RE: Initial Submission Review – Kings Point South PAS 1-4 – Site Plan
and Plat Application Number: DA-1628-06
Case Numbers: 2022-4037-00, 2022-3063-00

This letter is in response to the City of Aurora's comments dated August 26, 2022. Comment responses are shown in *red*.

PROJECT: KINGS POINT SOUTH
 DRAWING: SITE PLAN
 CLIENT: CITY OF AURORA
 DESIGNED BY: AJZ
 DRAWN BY: STM
 CHECKED BY: AJZ
 DATE: 9-21-2021

SHEET NUMBER
SP1
SHEET 07 OF 34
PROJECT NO. 8677-000

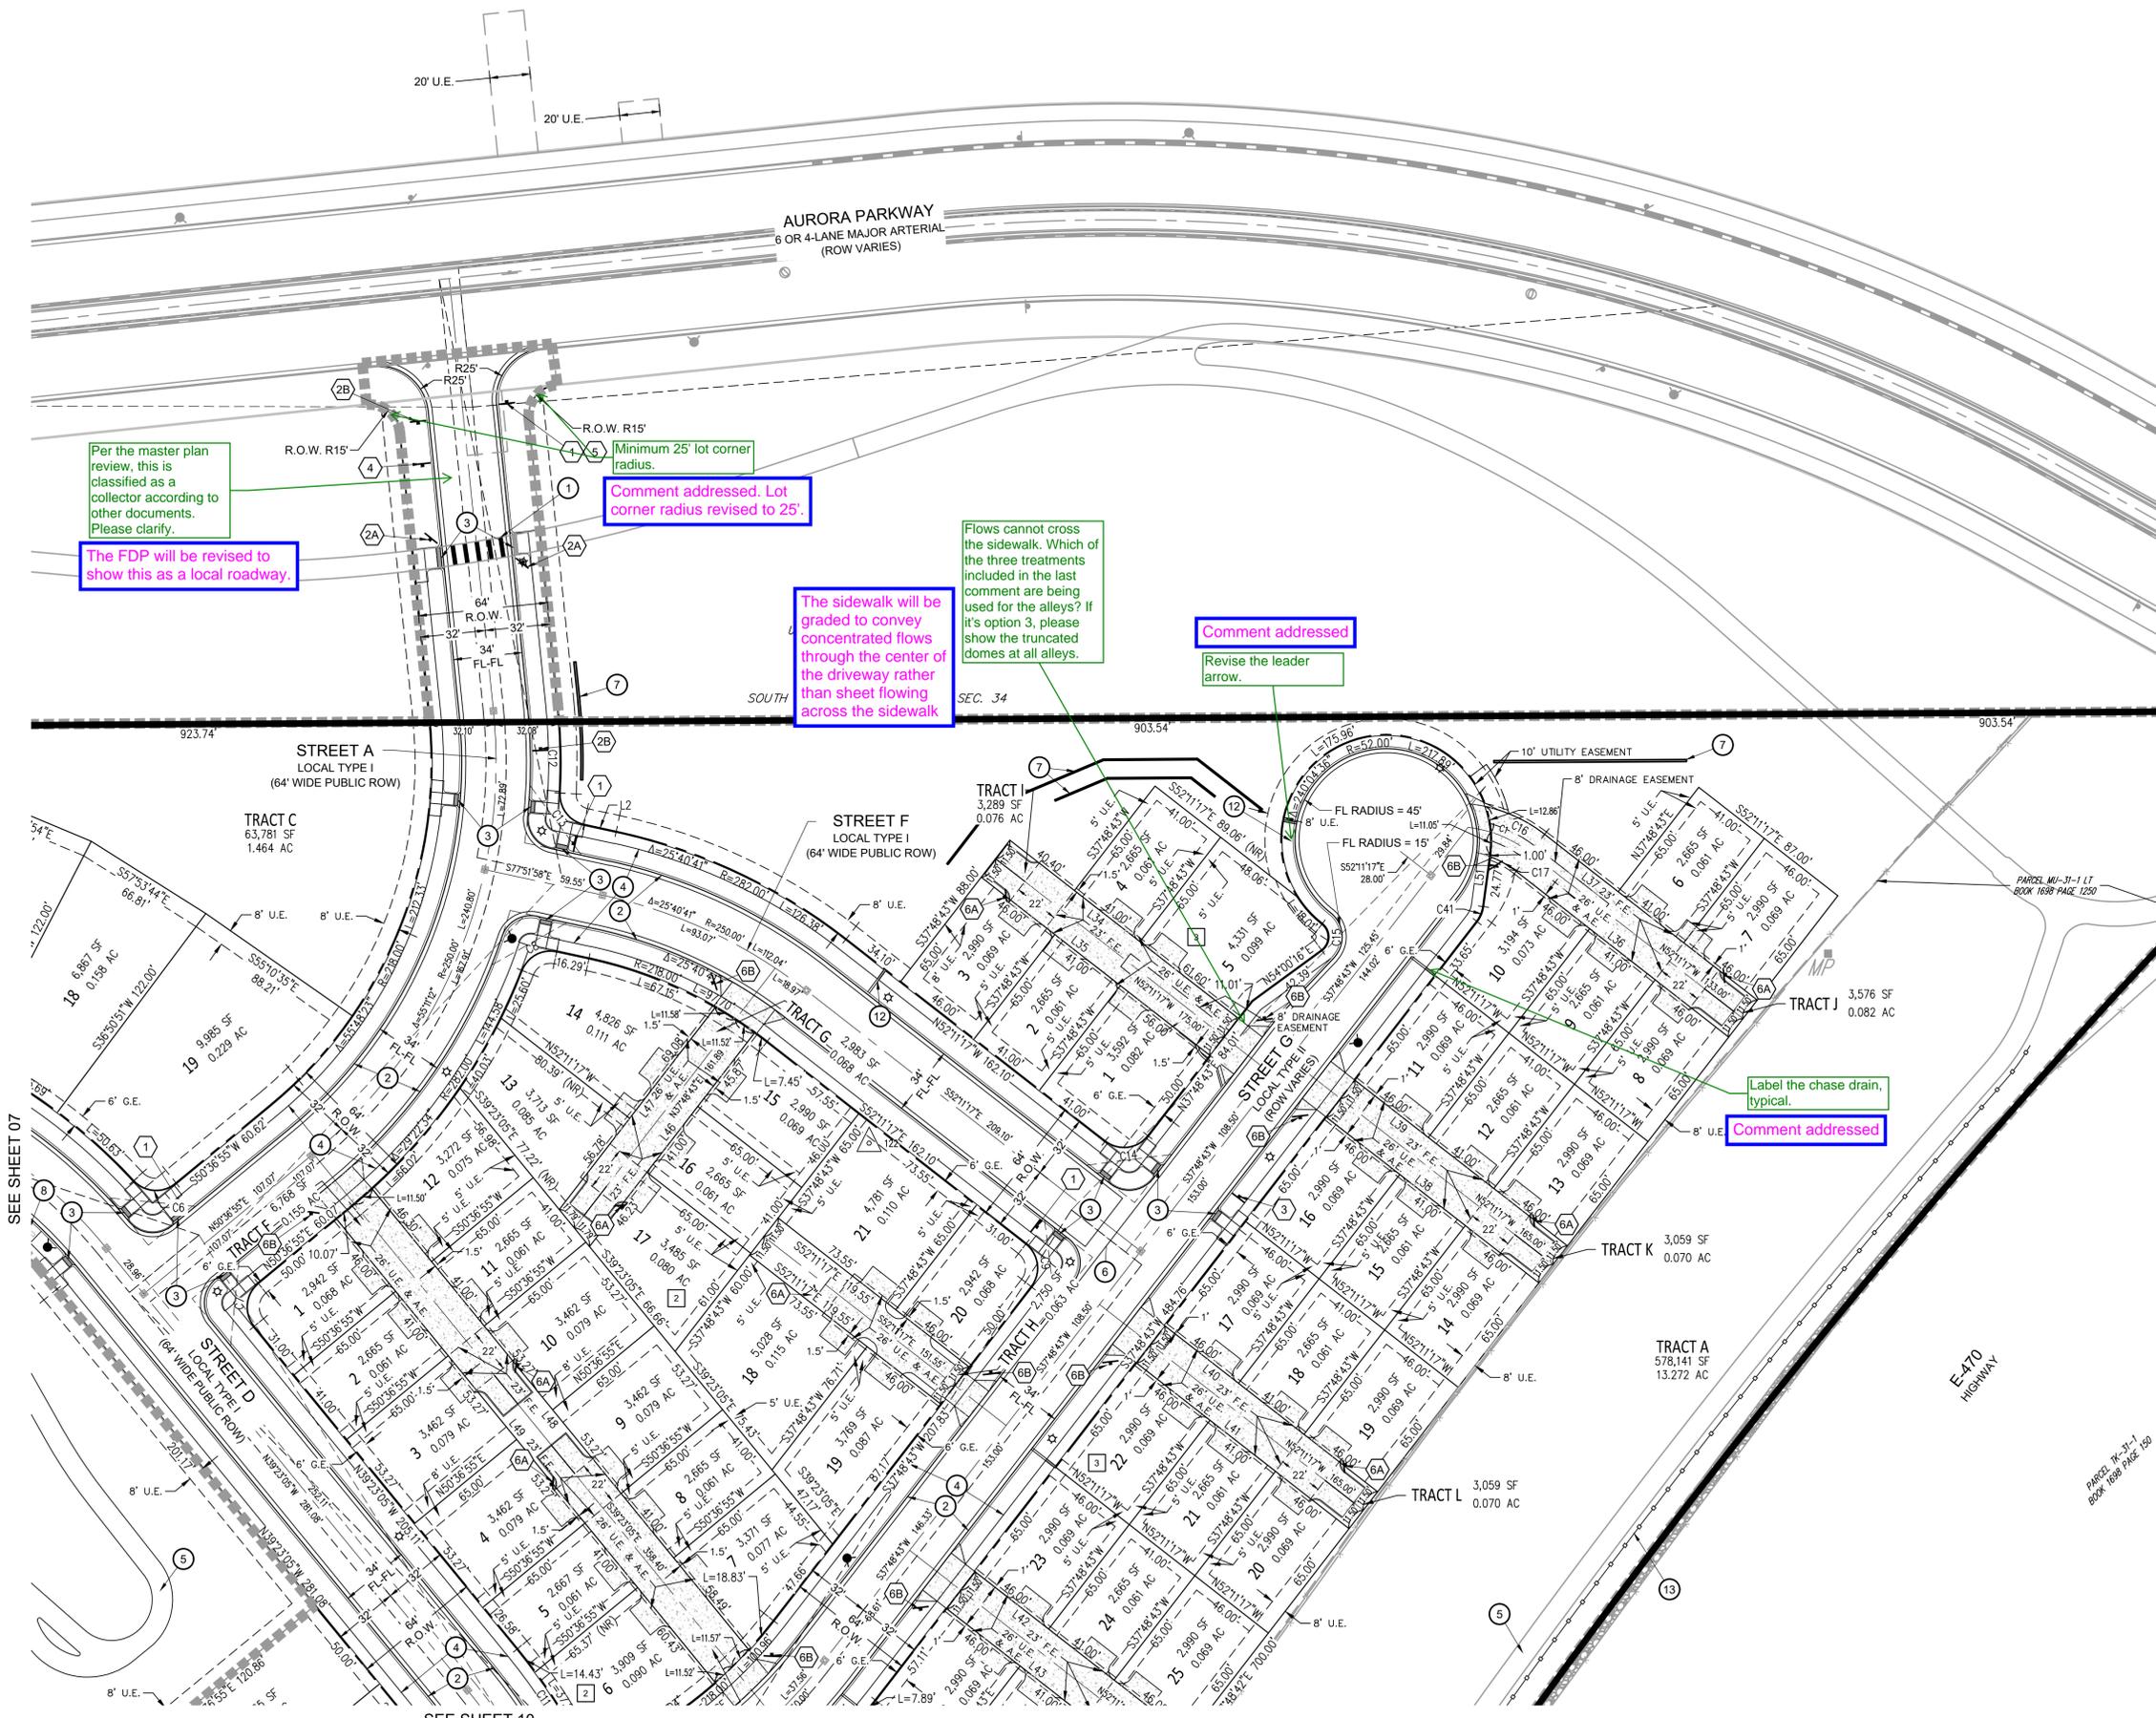
Provide streetlights along Kings Point Way if they are not provided with the Kings Point Way construction plans.

Per email correspondence with Julie on 10/27/22, it has been acknowledged that this is a Parker owned roadway and street lights will not be required with this application.

SHEET NUMBER: **L-1**

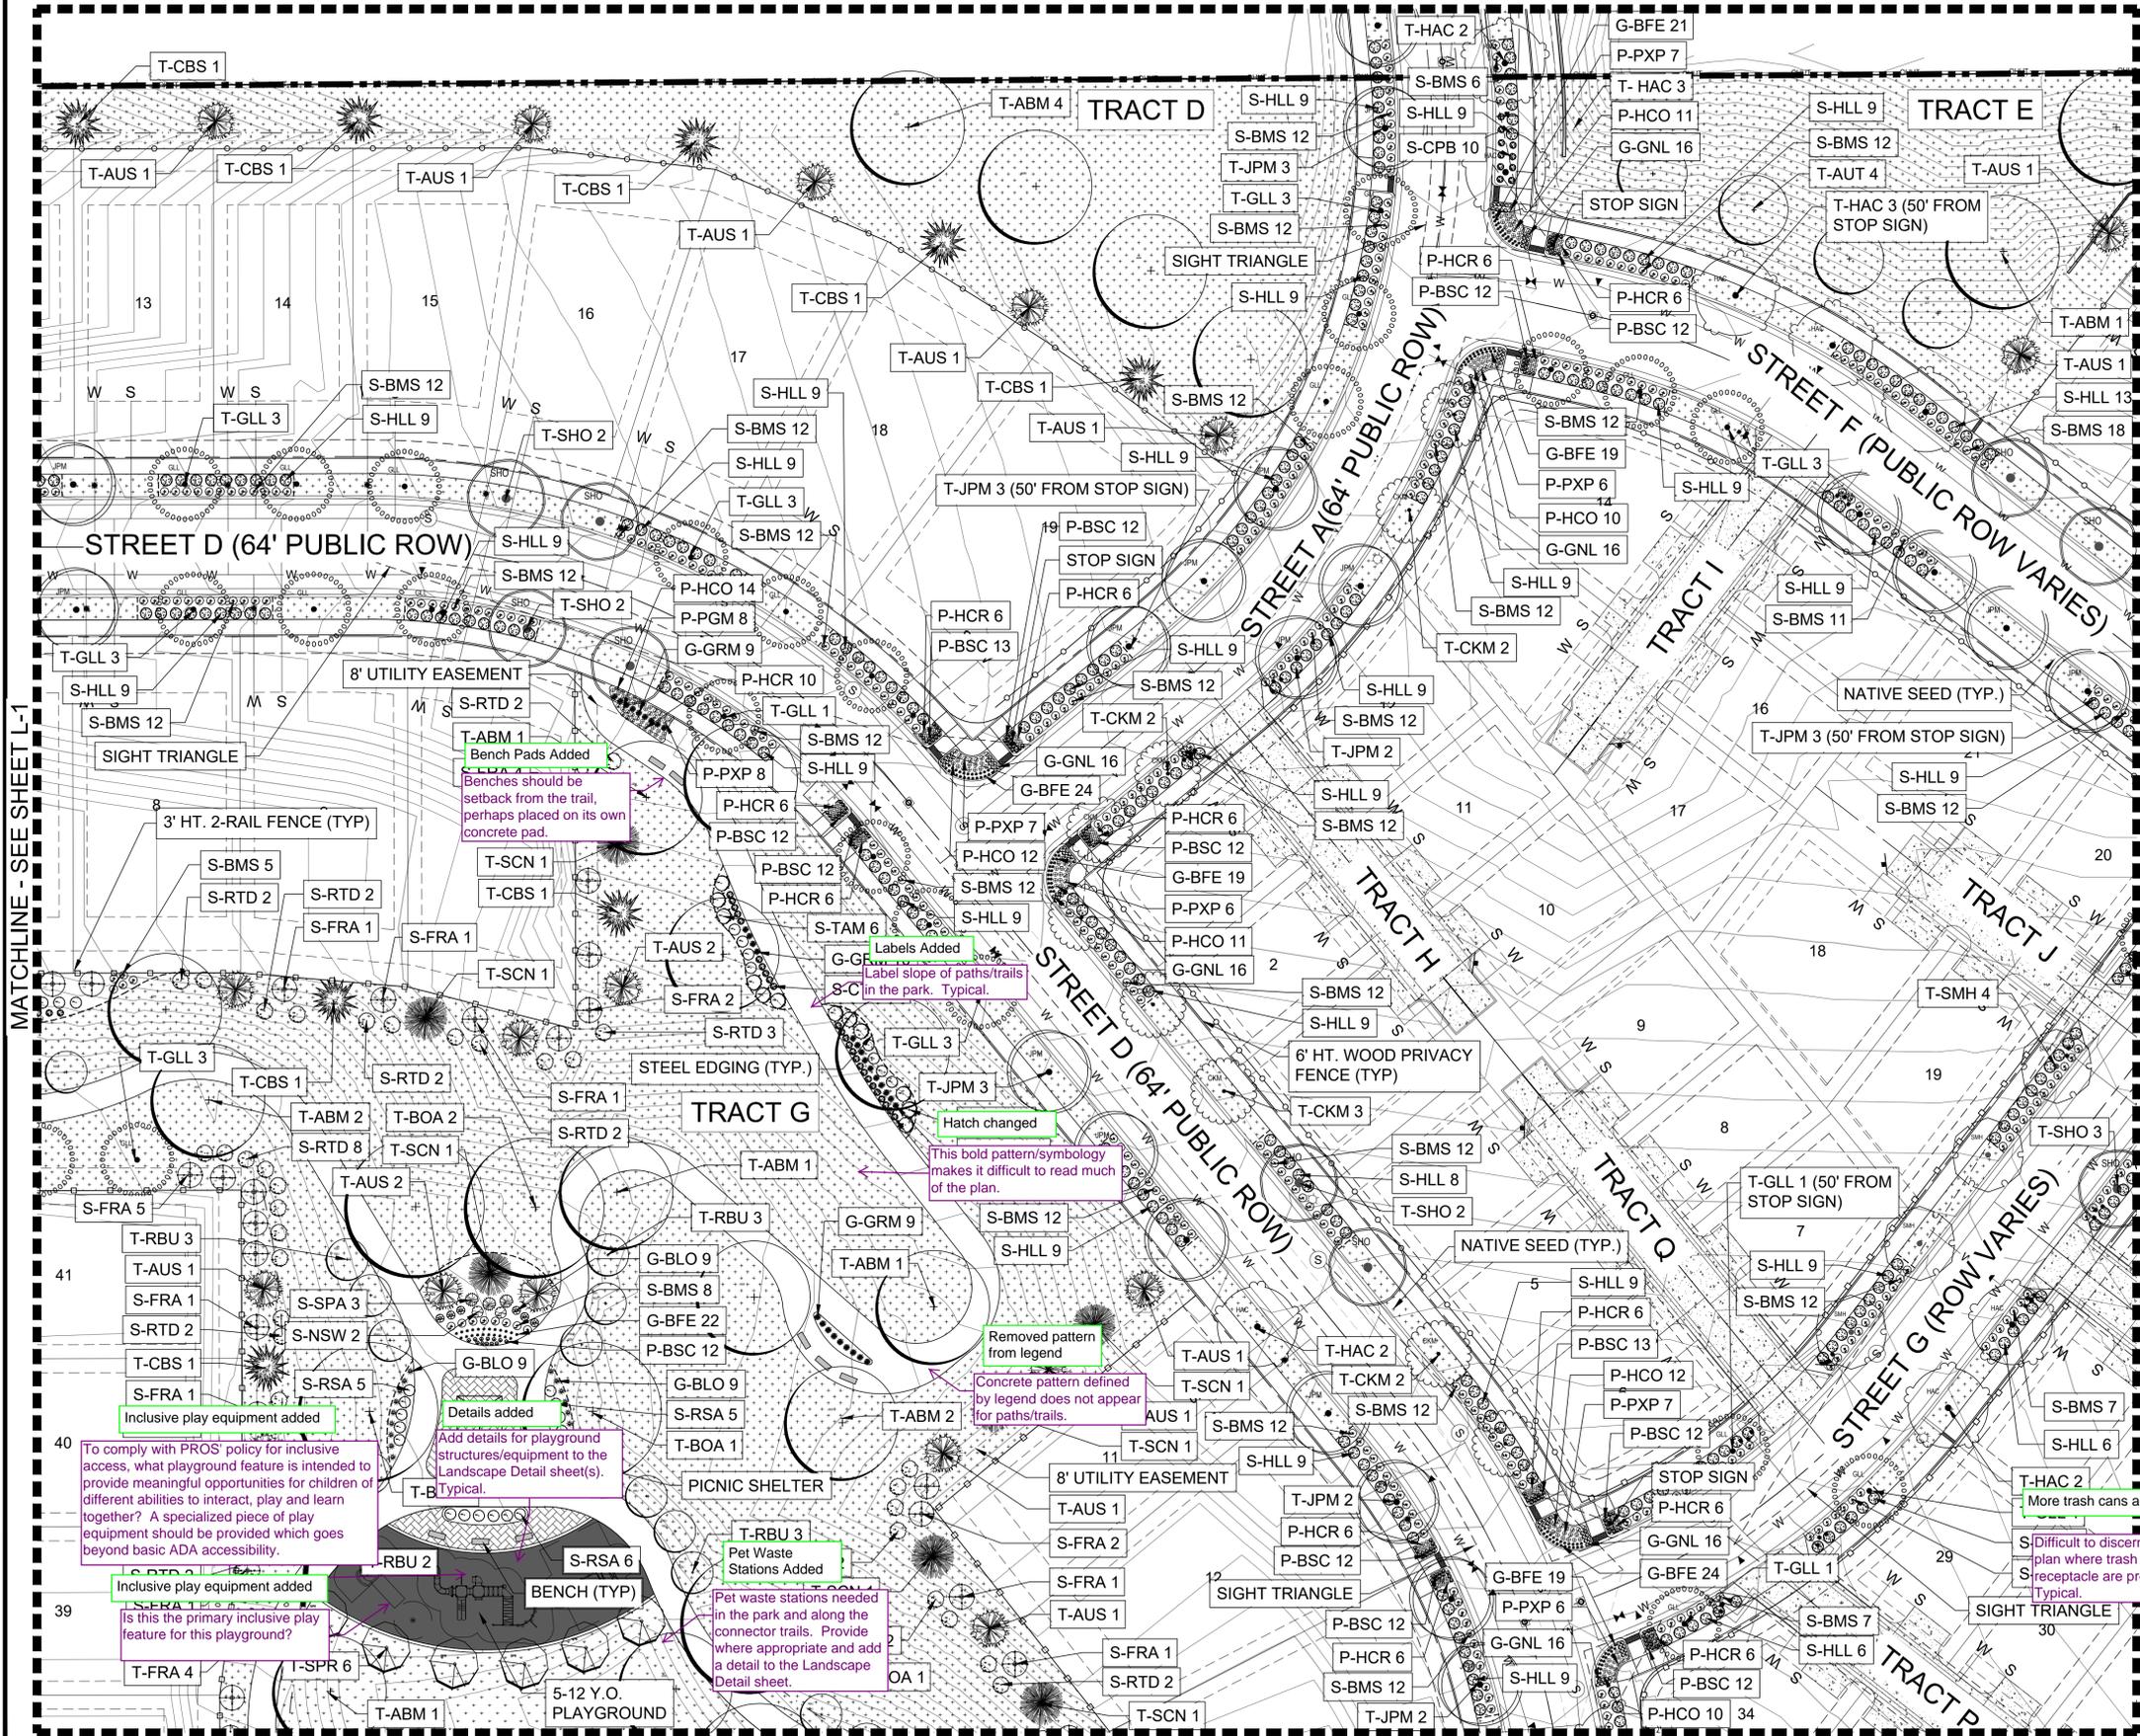
10D. 1. Provide sight triangles at all alley and motor court driveway approaches with public ROW
2. Several mature plant heights within sight triangles exceed COA 4.04.2.10 height requirements, verify all plant heights and replace as necessary. *Plants replaced in sight triangles*
